**Flood Control Project Maintenance  
Levee Inspections**  
**LMA District Cover Sheet**  
**Spring 2017 Levee Inspection Results**

**Reclamation District No. 0501 Ryer Island**

**Levee Inspection Report By Mile - Spring 2017**

Photo 1 of 1 : SP\_2017\_RD0501\_169\_42\_20170522\_00059.jpg

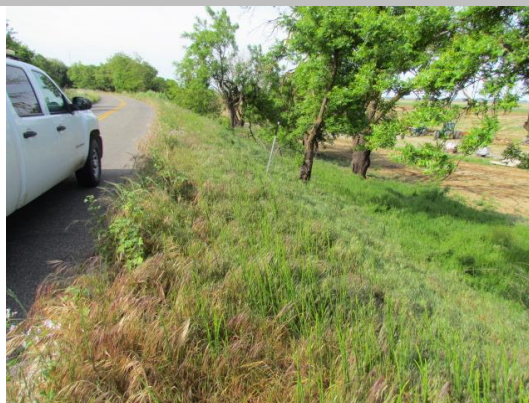
LM Start	0.04	Rating **	U	Issue No.	42
LM End	6.16	Issue Type +	Ma	Location *	LS
Category	Earthen Levee			GPS Latitude/Longitude	
				Start	End
Item	Vegetation			38.254035 °	38.185987 °
				-121.601790 °	-121.648192 °
DWR ID	DWR_RD0501_01_f_2016_42				
Comment Code					
V1 : Control annual grass and weeds on the levee slopes and easements.					
Inspector Comment					
Control the annual grasses and weeds from the landside slope.

Photo 1 of 3 : UCIP\_SP\_2017\_44720\_73904.jpg

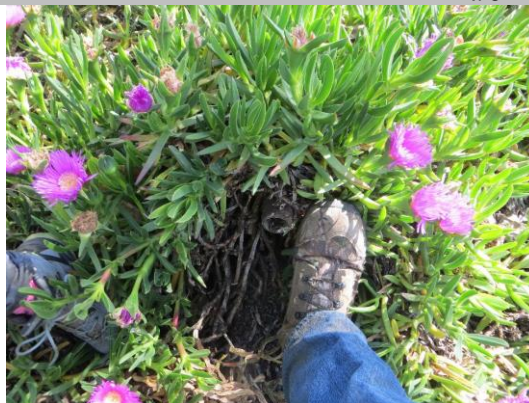
LM Start	4.57	Rating **	M	Issue No.	993
LM End	4.57	Issue Type +	En	Location *	LS
Category	Supplemental			GPS Latitude/Longitude	
				Start	End
Item	DWR UCIP Field Study			38.194438 °	38.194438 °
				-121.623063 °	-121.623063 °
DWR ID					
Comment Code					
Inspector Comment					
FS_ID:44720 DS_ID:21103 EP_NO: N/A Repair Type: Non-Urgent Crossing Status: Indicator Found UCIP Comments: Need to verify type of abandonment and if needed abandon it properly. FIELD_STRUCT_DESC: *ABANDONED* 12-inch pipe through the levee, 3.0 feet below the crown. (USACE-1959). This entry matches the Drainage or Irrigation Structure referenced in O&M manual (HLM 4.90). A 1.5-inch electrical conduit is visible on the LS slope 3-feet below the crown (good indicator for pipe crossing). FS Date: 4/21/2015

LM Start	<b>4.57</b>	Rating **	M	Issue No.	<b>993 (cont)</b>
LM End	<b>4.57</b>	Issue Type +	En	Location *	LS

Photo 1 of 1 : SP\_2017\_RD0501\_169\_1\_20170404\_00001.jpg

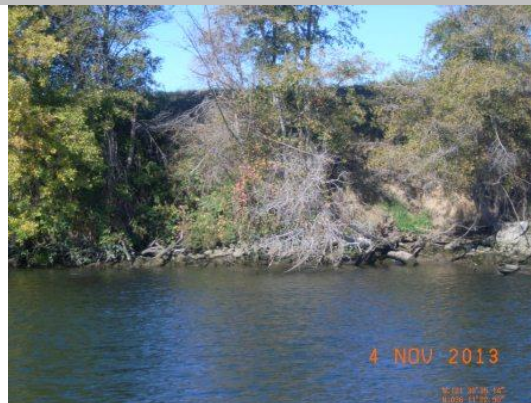
LM Start	5.77	Rating **	M	Issue No.	1
LM End	5.84	Issue Type +	Ma	Location *	WS
Category	Supplemental			GPS Latitude/Longitude	
				Start	End
Item	2015 USACE Erosion Survey, DRAFT			38.190001 °	38.189311 °
				-121.643160 °	-121.643917 °
DWR ID	DWR_RD0501_01_f_2016_1				
Comment Code					
Inspector Comment					
2008 - Overstepped levee section with multiple small pockets of erosion 10 - 20 ft wide. 2013 - Site has fresh erosion and taller vertical sections. 2015: No observed changes. [2015 Site ID: STM_15-7_R]

Photo 2 of 3 : UCIP\_SP\_2017\_19657\_33400.jpg

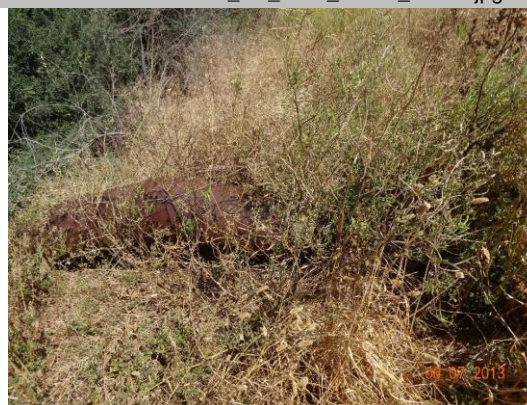
Comment Code					
Inspector Comment					
FS_ID:19657					
DS_ID:21046					
EP_NO: N/A					
Repair Type: Non-Urgent					
Crossing Status: Found					
UCIP Comments: Dense vegetation limits the inspector's visibility to identify signs of pipe failure (leaks) through the waterward slope. Recommend removing vegetation along pipe alignment to conduct proper inspection of structure and appurtenances.					
FIELD_STRUCT_DESC: 16-inch pipe sleeved through a 20-inch pipe through the levee, 4.7 feet below the crown. Annular gap grouted. Siphon breaker on landward shoulder. Pipe exposed along both slopes. (USACE-1959). This entry matches the Drainage or Irrigation Structure referenced in O&M manual (HLM 3.30). The 16-inch pipe was sleeved through pre-existing pipe under Permit No. 2645 (1959).					
FS Date: 8/22/2013

Photo 1 of 2 : UCIP\_SP\_2017\_32541\_59008.jpg

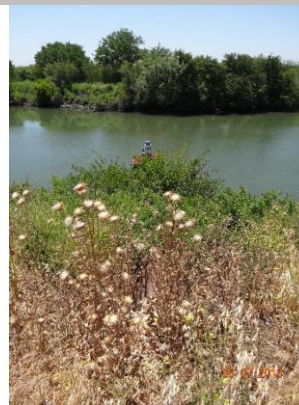
LM Start	4.75	Rating **	M	Issue No.	143
LM End	4.75	Issue Type +	En	Location *	LS
Category	Supplemental			GPS Latitude/Longitude	
				Start	End
Item	DWR UCIP Field Study			38.281041 °	38.281041 °
				-121.640904 °	-121.640904 °
DWR ID

Comment Code					
Inspector Comment					
FS_ID:32541 DS_ID:21071 EP_NO: N/A Repair Type: Non-Urgent Crossing Status: Found UCIP Comments: --Contact owner--Dense vegetation limits the inspector's visibility to identify signs of pipe failure (leaks) along the waterward and landward slopes. Recommend removing vegetation along pipe alignment to conduct proper inspection of structure and appurtances. Walkway and siphon breaker not found. FIELD_STRUCT_DESC: 12-inch concrete pipe through the levee, 2.5 feet below the crown. Cutoff wall around pipe at center of levee. Siphon breaker on apex of pipe at shoulder. Pump on pile structure in stream. Walkway access to pump. (USACE-1959). This entry matches the Drainage or Irrigation Structure referenced in O&M manual (HLM 5.10). FS Date: 6/7/2013

Photo 1 of 3 : UCIP\_SP\_2017\_50025\_59039.jpg

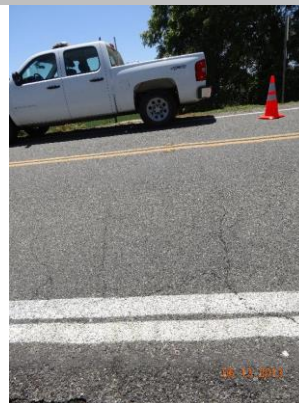
LM Start	7.59	Rating **	M	Issue No.	153
LM End	7.59	Issue Type +	En	Location *	LS
Category	Supplemental			GPS Latitude/Longitude	
				Start	End
Item	DWR UCIP Field Study			38.286153 °	38.286153 °
				-121.607959 °	-121.607959 °
DWR ID

Comment Code					
Inspector Comment					
FS_ID:50025 DS_ID:21063 EP_NO: 11812 Repair Type: Non-Urgent Crossing Status: Found UCIP Comments: 8/22/2016 Crossing has been downgraded from Urgent to Non-Urgent no levee damage appears to be present along pipe alignment. There appears to be an erosion site adjacent to this crossing. Need to coordinate with DWR Inspectors. (DWR UCIP - omagana)6/07/2013 Open cut section of levee on LS slope 8 foot wide--repair work needed. Abandoned pump on waterward berm. Dense vegetation--Recommend removing vegetation along pipe alignment to conduct proper inspection of structure and appurtenances on waterward side. (DWR UCIP - omagana) FIELD_STRUCT_DESC: 14-inch steel pipe and 1.25-inch electrical conduit through the levee, both 3.0 feet below the crown. Cutoff wall around pipe and conduit at center of levee. Siphon breaker on apex of pipe at landward shoulder. Slant pump on waterward slope. Discharge structure at landward toe. Rock revetment on waterward slope. (Permit No. 11812-1976) FS Date: 8/22/2016

Photo 1 of 3 : UCIP\_SP\_2017\_32546\_59047.jpg

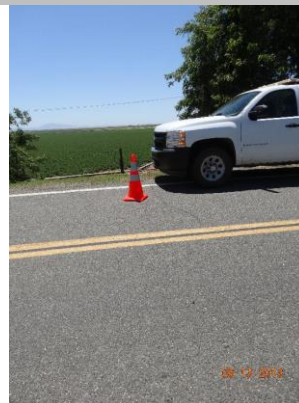
LM Start	7.60	Rating **	M	Issue No.	154
LM End	7.60	Issue Type +	En	Location *	LS
Category	Supplemental			GPS Latitude/Longitude	
				Start	End
Item	DWR UCIP Field Study			38.286134 °	38.286134 °
				-121.607920 °	-121.607920 °
DWR ID

Comment Code					
Inspector Comment					
FS_ID:32546 DS_ID:21064 EP_NO: N/A Repair Type: Non-Urgent Crossing Status: Found UCIP Comments: Debris (pipe section) located on waterward berm. Dense vegetation limits the inspector's visibility to identify signs of pipe failure (leaks) along the waterward slope. Recommend removing vegetation along pipe alignment to conduct proper inspection of structure and appurtenances. FIELD_STRUCT_DESC: 8-inch steel pipe through the levee, 2.7 feet below the crown. Pump in pump house at landward toe. (USACE-1959). This entry matches the Drainage or Irrigation Structure referenced in O&M manual (HLM 8.20). FS Date: 6/13/2013

Photo 2 of 3 : UCIP\_SP\_2017\_32551\_59072.jpg

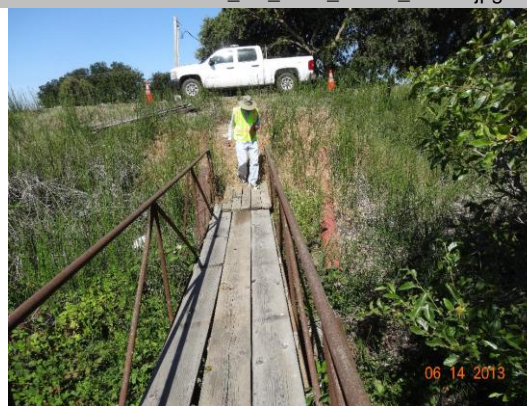
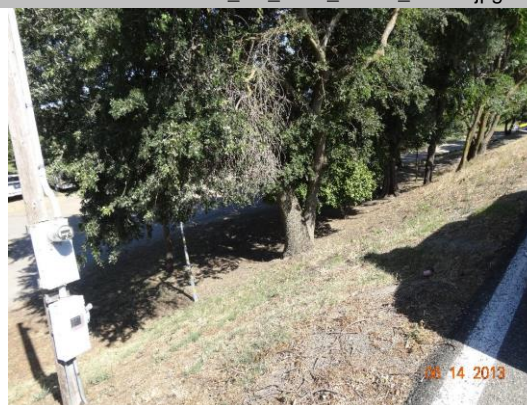
Comment Code						
Inspector Comment						
FS_ID:32551 DS_ID:21074 EP_NO: N/A Repair Type: Non-Urgent Crossing Status: Found UCIP Comments: Unable to determine status of crossing. Pipe visible on waterward side--could be the pipe that was supposed to be removed under permit number 13983 (1985). Also present is a 1.5 inch conduit along the 8 inch pipe. Need to coordinate with owner. FIELD_STRUCT_DESC: 8-inch steel pipe through the levee, 6.4 feet below the crown. Pump on pile structure in stream. Service pole on landward slope. (USACE-1959). This entry matches the Drainage or Irrigation Structure referenced in O&M manual (HLM 1.30). Pipe should have been removed and replaced with 12-inch pipe under Permit No. 13983 (1985). FS Date: 6/13/2013

LM Start	1.17	Rating **	M	Issue No.	22 (cont)
LM End	1.17	Issue Type +	En	Location *	WS

Photo 3 of 3 : UCIP\_SP\_2017\_32552\_59075.jpg

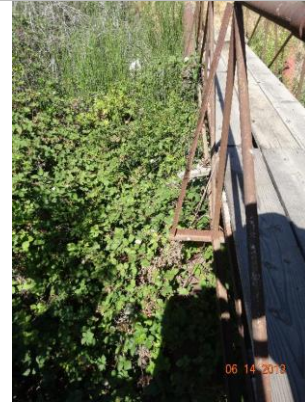
LM Start	1.17	Rating **	M	Issue No.	23 (cont)	
LM End	1.17	Issue Type +	En	Location *	WS	
Category	Supplemental			GPS Latitude/Longitude		
				Start	End	
Item	DWR UCIP Field Study			38.270156 °	38.270156 °	
				-121.604403 °	-121.604403 °	
DWR ID

Comment Code						
Inspector Comment						
FS_ID:32552						
DS_ID:21095						
EP_NO: 13983						
Repair Type: Non-Urgent						
Crossing Status: Found						
UCIP Comments: Abandoned pipe was to be removed during the installation of new 12-inch pipe crossing. Need to contact pipe owner. Unable to confirm crossing--need additional records for crossing.						
FIELD_STRUCT_DESC: 12-inch steel pipe through the levee, 5.0 feet below the crown. Cutoff wall around pipe at center of levee. Siphon breaker on apex of pipe at landward shoulder. Pump on pile structure in stream. Service pole on landward slope. Pipe connects to 10-inch steel pipe along the landward slope at the shoulder, and similarly to pre-existing 8-inch pipe on the waterward side. (Permit No. 13983-1985)						
FS Date: 6/13/2013

Photo 3 of 3 : UCIP\_SP\_2017\_32553\_59080.jpg

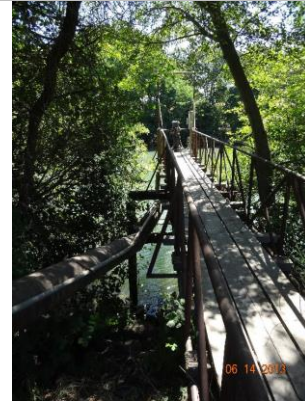
LM Start	1.86	Rating **	M	Issue No.	25 (cont)
LM End	1.86	Issue Type +	En	Location *	LS
Category	Supplemental			GPS Latitude/Longitude	
				Start	End
Item	DWR UCIP Field Study			38.260407 °	38.260407 °
				-121.601365 °	-121.601365 °
DWR ID

Comment Code					
Inspector Comment					
FS_ID:32553 DS_ID:21077 EP_NO: N/A Repair Type: Non-Urgent Crossing Status: Found UCIP Comments: Dense vegetation limits the inspector's visibility to identify signs of pipe failure (leaks) along the waterward and landward slope. Recommend removing vegetation along pipe alignment to conduct proper inspection of structure and appurtenances. FIELD_STRUCT_DESC: 14-inch steel pipe through the levee, 8.0 feet below the crown. 2 inch conduit goes through levee. Siphon breaker on landward slope. Pump on pile structure in stream. (USACE-1959). This entry matches the Drainage or Irrigation Structure referenced in O&M manual (HLM 2.0). FS Date: 6/13/2013
